Before the
FEDERAL COMMUNICATIONS COMMISSION
Washington, DC 20554

In the Matter of)	
)	
Space Exploration Holdings, LLC)	Call Signs S2983 and S3018
)	
Application for Modification of)	File No. SAT-MOD-20181108-00083
Authorization for the SpaceX NGSO)	
Satellite System)

PETITION TO DENY OR DEFER OF WORLDTVU SATELLITES LIMITED

A.) Inline geometries with one SEH Ku-band user link

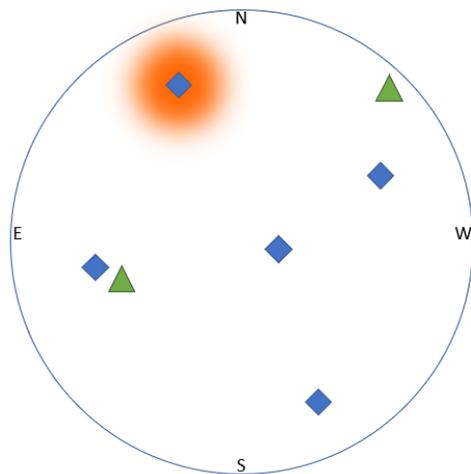
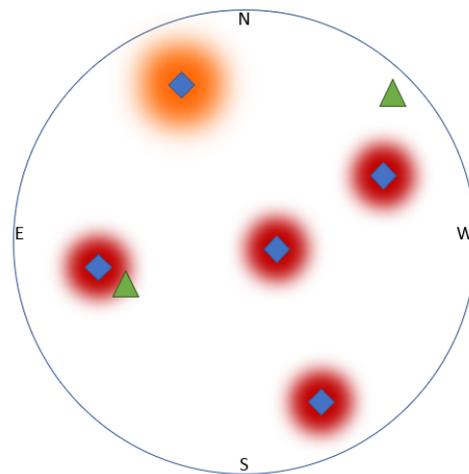
The figures below depict a view of the sky, looking upward from an SEH earth station on the ground, collocated with another NGSO system’s earth station. In the sky at this moment in time are five SEH satellites (shown by blue diamonds) and two NGSO satellites of another system (shown by green triangles and labeled “Wanted NGSO Satellite”). The positions of the various satellites are randomly chosen for purpose of this illustration of the problem.

The first graphic (Case A on the left) depicts the interfering signal from the SEH system before SEH’s proposed modification. There is only one SEH satellite that is transmitting in Ku-band toward the earth station in this instant, shown with an orange glow. This is because, prior to its proposed system modification, SEH intended to use the Ku-band only for service links. If the other (“wanted”) NGSO system pointed its earth station in the direction of this orange glow, it would receive unacceptable interference from SEH. At this moment, however, the angular separation between the single SEH satellite (with the orange glow) and both of the two wanted NGSO satellites means that the wanted NGSO earth station should have no difficulty receiving transmissions from either of the two wanted NGSO satellites.

B.) Inline geometries with one SEH Ku-band user link and four SEH Ku-band gateway links

The second graphic (Case B on the right) depicts the interfering signals from the SEH NGSO system after the proposed modification to multiply the number of interfering space stations by five. Instead of only a single SEH satellite using the Ku-band for a user link, there are now four additional satellites that are also using the Ku-band for gateway links to this same Earth location. As demonstrated in Case B, SEH’s proposed modification will greatly increase the area of the sky that is inaccessible to other NGSO systems due to interfering signals from SEH. Although SEH does commit to decreasing the EIRP of each gateway downlink by up to 6 dB, this does not mitigate the near 500% increase in the probability of in-line events causing *actual*—not potential—harmful interference.¹² Additionally, in the depicted moment for Case B, instead of having two satellite options for communications, the other NGSO system would only have a single satellite option available to its wanted earth station. Moreover, this single option has increased interference relative to Case A because of two factors: reduced angular separation

from the nearest interfering SEH satellite (which may or may not be offset by SEH's promised EIRP reduction) and the aggregation of both user and gateway interfering signals from the multiple SEH satellites in view. In this specific example, the only available communications option for the other NGSO system is also at a lower elevation angle and thus may result in a lower carrier signal in addition to the increased interference.
